RE: Response Letter
61 John Vertente Boulevard – New Bedford, MA
SE 049-0791

On behalf of the applicant, Tim Cusson and 61 SMRE, LLC, please find revised Site Plans and HydroCAD© calculations enclosed with this letter. Revisions have been made in response to the comment email prepared by the Nitsch Engineering dated May 11, 2018 in regards to their review of the Site Plans. Our responses to the comments provided in the review letter are provided on the following pages.

Nitsch Comments

RAIN GARDEN (PROFILE)

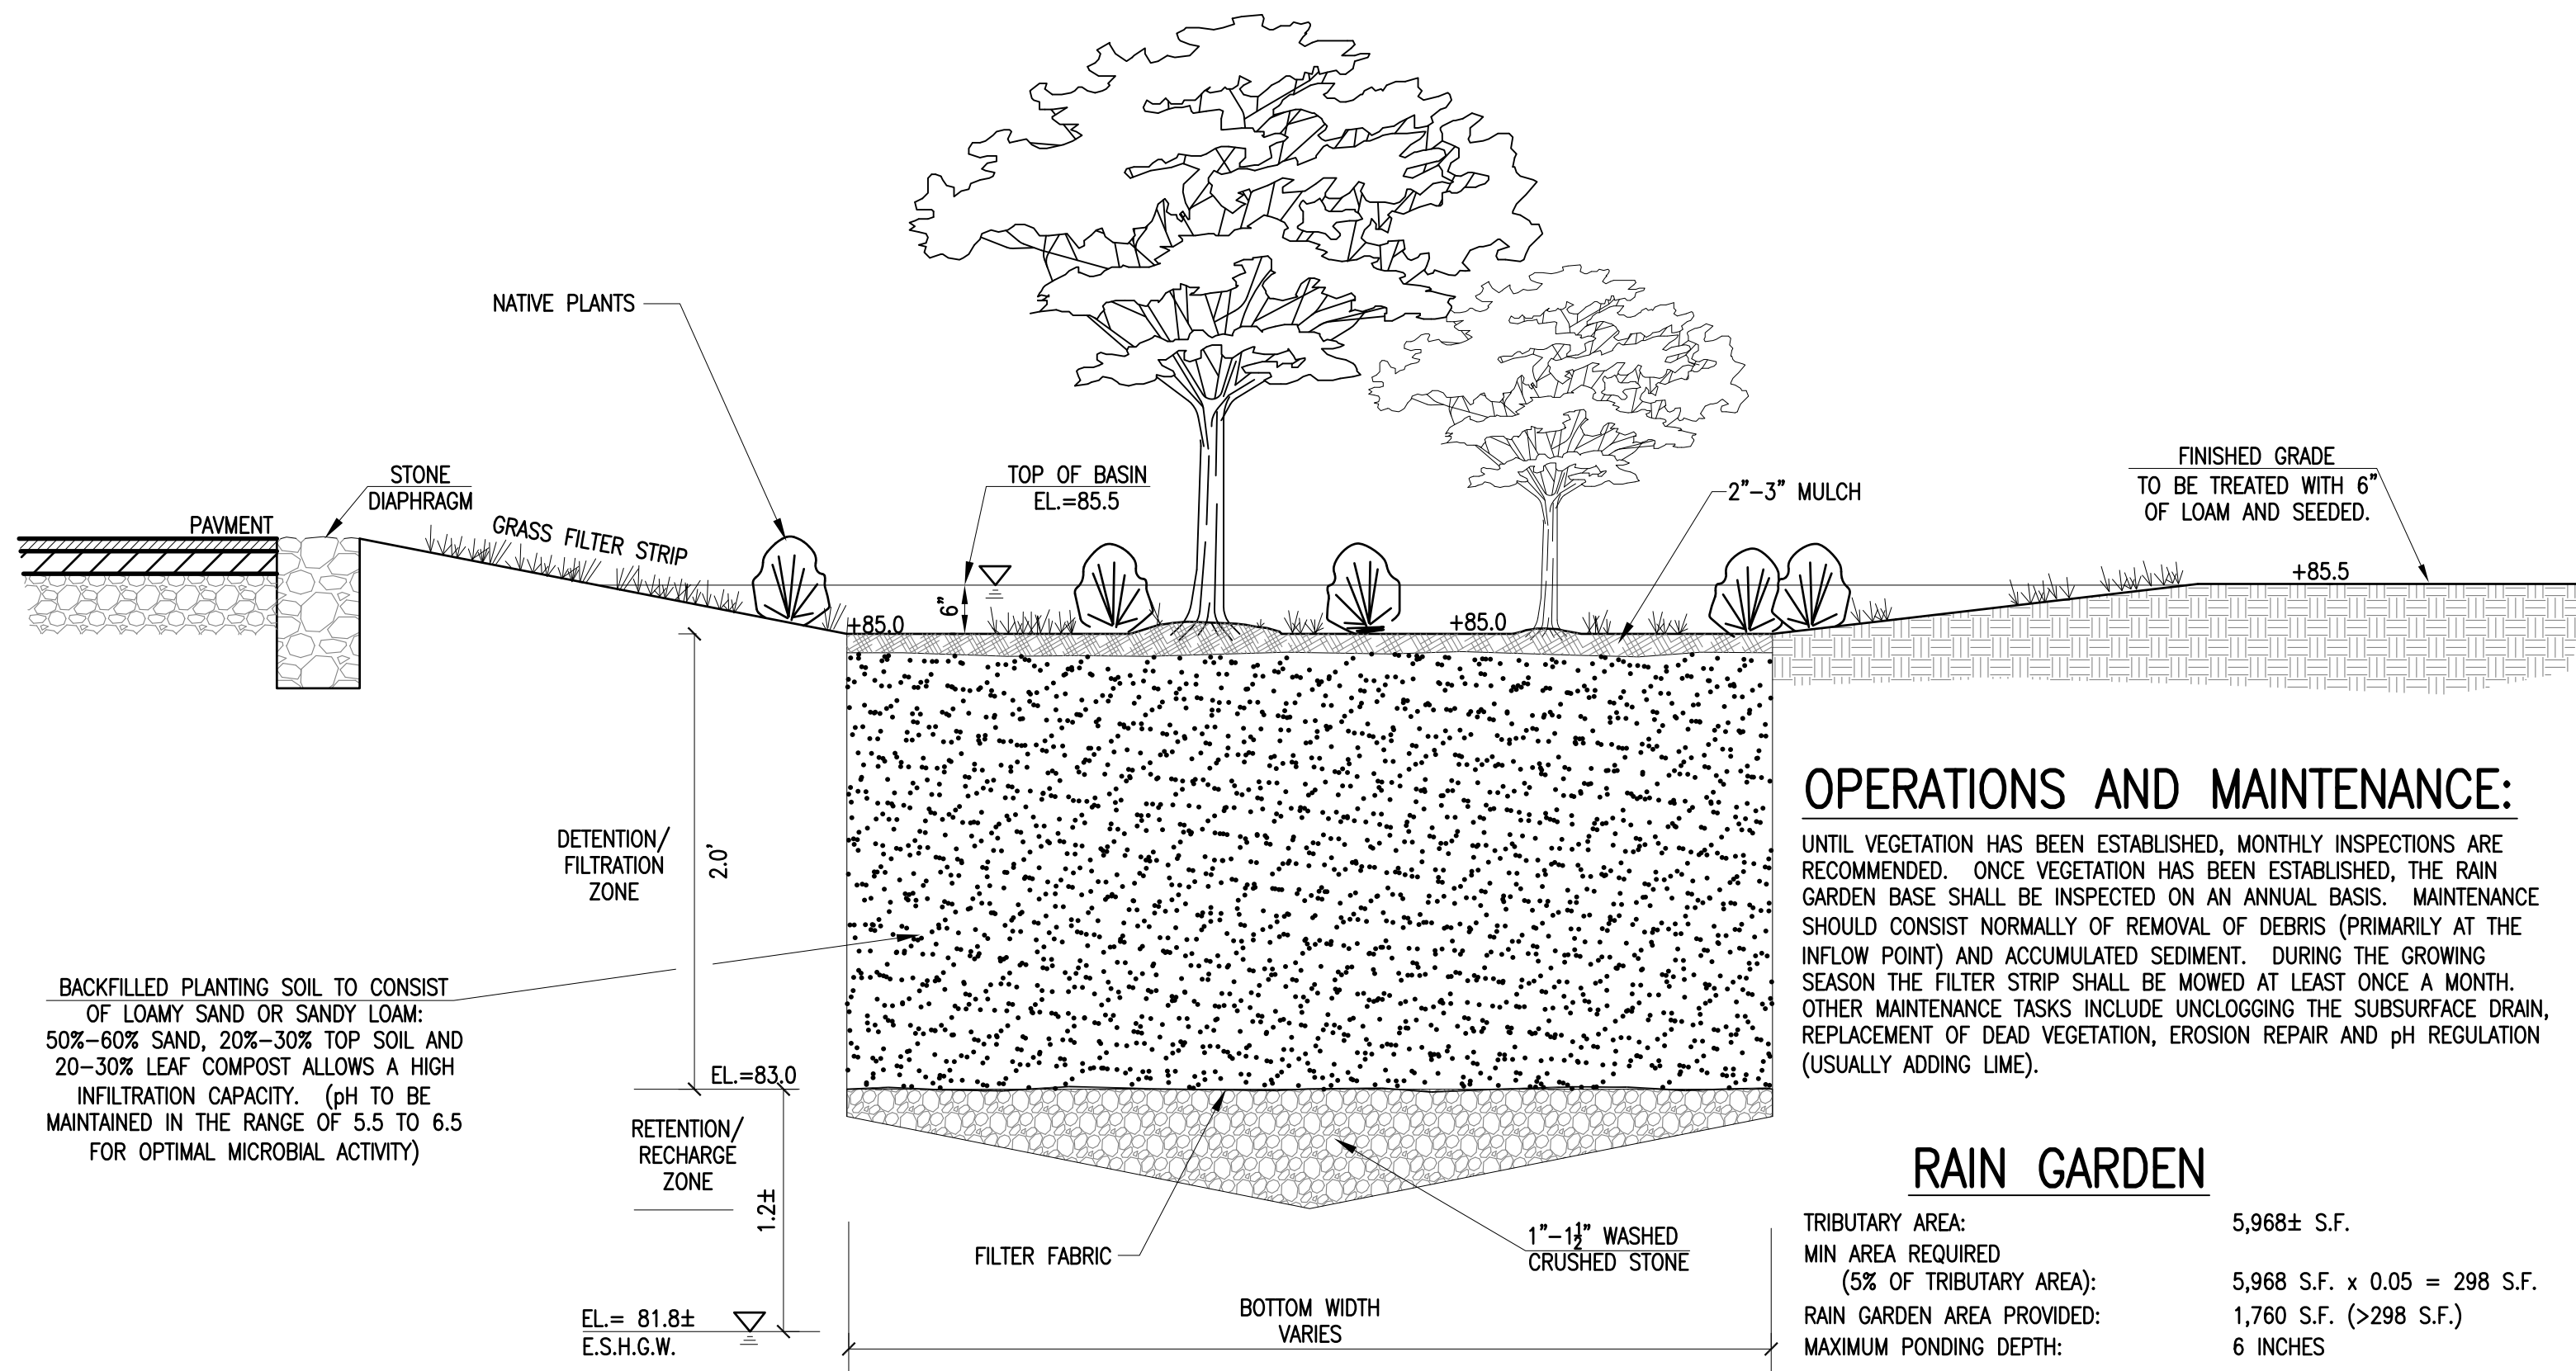
The drainage calculations show the bottom of the rain garden to be elevation 84. The site plans, and the rain garden detail, show the bottom of the rain garden at elevation 85. The broad crested stone outlet implies the bottom of the rain garden is 84. The calculations and the plans need to be consistent.

The HydroCAD calculations have been revised to be consistent with the Site Plan and Details.

The rain garden detail shows two feet of depth of planting soil. The Stormwater Management Standards recommend 2.5 feet to four feet of planting soil in rain gardens. The response to comments states that the rain garden has been designed to meet the Standards to the maximum extent practicable and the Applicant is requesting relief from providing the depth of planting soil described in the Standards. The Standards also require that two feet of groundwater separation be provided between the bottom of the raingarden and seasonal high groundwater. The plans show 1.2 feet of separation between the bottom of the planting soil and seasonal high groundwater. We consider the bottom of the raingarden to be the stone layer below the planting soil. Therefore, the separation is effectively less than the 1.2 feet shown on the plans. The depth of the stone is unlabeled. However, it is likely to be a minimum of six inches, which results in less than one foot of separation between seasonal high groundwater and the bottom of the rain garden. Given the site conditions it is unlikely that the rain garden can be built to comply with this requirement. Groundwater elevations are simply too high.

Due to the restrictive conditions of the site, Farland Corp. will defer to the conditions of the commission to the appropriate depths of both the planting media and separation from groundwater.
